State of New Mexico  
Energy, Minerals and Natural Resources

WELL API NO.	30-015-38509
5. Indicate Type of Lease	STATE <input checked="" type="checkbox"/> FEE <input type="checkbox"/>
6. State Oil & Gas Lease No.	
7. Lease Name or Unit Agreement Name	Marathon 25 State
8. Well Number	031
9. OGRID Number	372290
10. Pool name or Wildcat	Red Lake, Queen-Grayburg- San Andres
11. Elevation (Show whether DR, RKB, RT, GR, etc.)

SUNDRY NOTICES AND REPORTS ON WELLS  
(DO NOT USE THIS FORM FOR PROPOSALS TO DRILL OR TO DEEPEN OR PLUG BACK TO A DIFFERENT RESERVOIR. USE "APPLICATION FOR PERMIT" (FORM C-101) FOR SUCH PROPOSALS.)

**Proposed P&A Procedure**

**Proposed P&A**

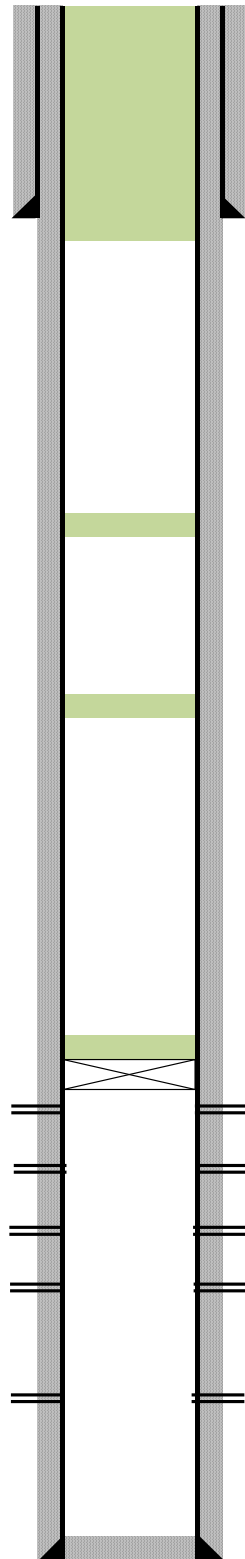
**APPROVED  
GC 3/18/26**

1. MIRU pull rods NU BOP pull tubing.
2. RU wireline run GR/JB to 2,649' set CIBP 2,649'.
3. Load and roll hole pressure test casing 500psi for 30 minutes.
4. Run CBL **with zero psi** from 2,649', **keep hole loaded and log** to surface.
5. TIH spot 25 sxs of class C cement on top of CIBP, WOC tag at 2,400'.
6. MUH at 2,238', **43** sxs of class C cement tag at 1,858' (San Andres, Grayburg).
7. MUH 25 sxs of class C cement from 1,570' to 1,320' (Queen).
8. MUH 50 sxs of Class C from 484' to surface. **WOC & Bubble Test**
9. Cut off well head, install dry hole marker.

**Plugs may change based on  
CBL.**

Created By	Condition	Condition Date
gcordero	Adhere to current Plug & Abandon (P&A) Conditions Of Approvals (COA).	3/18/2026
gcordero	A Cement Bond Log (CBL) is required to be submitted to electronic permitting.	3/18/2026
gcordero	Submit Cement Bond Logs (CBL) prior to submittal of C-103P.	3/18/2026
